Project	IEEE 802.16 Broadband Wireless Access Working Group < http://ieee802.org/16 >
Title	CR on SDD Section 17: Facilitating Entry of New Femto BS into the Network
Date Submitted	2009-02-24
Source(s)	Karthik Sundaresan, Sampath Rangarajan, karthiks@nec-labs.com Linghang Fan, Nader Zein, Tetsu Ikeda, Andreas Maeder, Amir Khojastepour, Mohammad Madihian NEC
Re:	Change request to Project 802.16m System Description Document (SDD) (IEEE 802.16m-08/003r7)
Abstract	This contribution provides text addition to SDD to facilitate entry of a new femto BS into the network.
Purpose	For discussion and approval by IEEE 802.16m TG
Notice	<i>This document does not represent the agreed views of the IEEE 802.16 Working Group or any of its subgroups. It represents only the views of the participants listed in the "Source(s)" field above. It is offered as a basis for discussion. It is not binding on the contributor(s), who reserve(s) the right to add, amend or withdraw material contained herein.</i>

Facilitating Entry of New Femto BS into the Network

Figure 1. Femto/Macro Network Illustration.

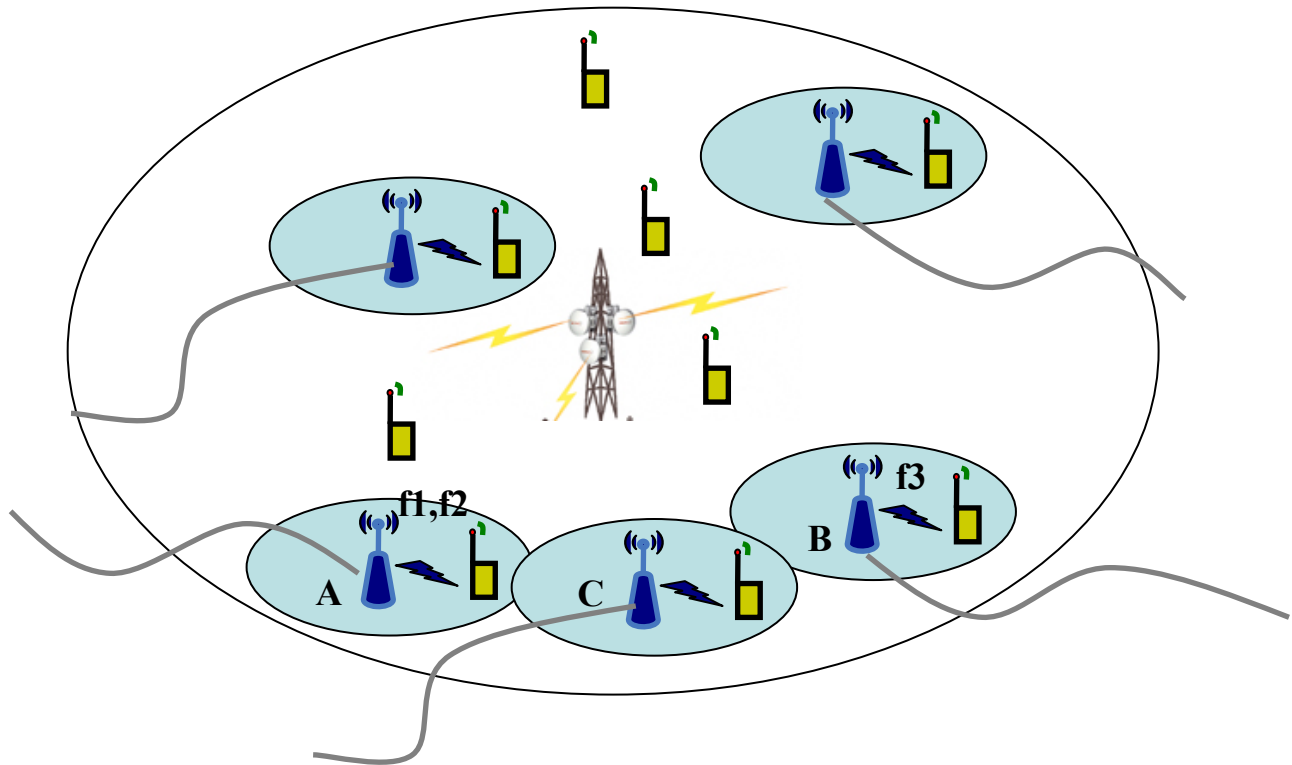
It is often possible that the macro BS may not be able to coordinate resource allocation among femto cells and the femto BS have to autonomously determine their resource region. This is especially likely in moderate to high load scenarios. The SDD currently specifies that a femto BS will measure power on all carriers from neighboring femto/micro/macro BS and accordingly choose a carrier perceived to have low interference. However, in moderate to high load scenarios, where the available resources are being utilized by existing femto BS, a new femto BS entering the network is likely to see high interference on all available resources from its neighboring femto/micro cells. This could potentially result in starvation of the new femto cell being deployed in the network. For eg., consider the scenario shown in Figure 1, where there are three carriers/channels available in the network: f_1, f_2 and f_3 . Femto BS A and B have already been deployed and split the resources as say $f_1 + f_2$ for A and f_3 for B. Now when the femto BS C gets deployed, it finds strong interference on all the available carriers from

its neighbors. This leads to starvation of the newly deployed femto BS C and its associated clients. This problem is exacerbated in cases, where there is no coordination of resources (to be used by the femto BS) by the macro BS and the femto BS have to autonomously determine their resource region of operation.

To address this starvation problem, it is essential for the femto BS to have the notion of “resource readjustment”. This essentially means that mechanisms for (centralized/distributed) resource allocation should be executed by the femto/macro BS either periodically or based on triggers (eg. entry of new femto BS), which would allow for resources to be shared fairly taking into account the change in network and load dynamics. In the above example, a periodic resource allocation mechanism would trigger the three femto BS to enter into a resource re-allocation phase, whereby the three frequencies would get shared as f1 for A, f2 for C and f3 for B respectively.

It is possible that when a new femto BS is initially deployed, all channels (carriers) could be occupied by neighboring femto/micro BS. In such scenarios, the new femto BS will see high interference level on all channels, resulting in its consequent starvation. To avoid such scenarios, which are common in moderate-high load conditions, mechanisms (centralized/distributed) for resource allocation at the femto/micro BS should be enabled either periodically or based on network triggers.
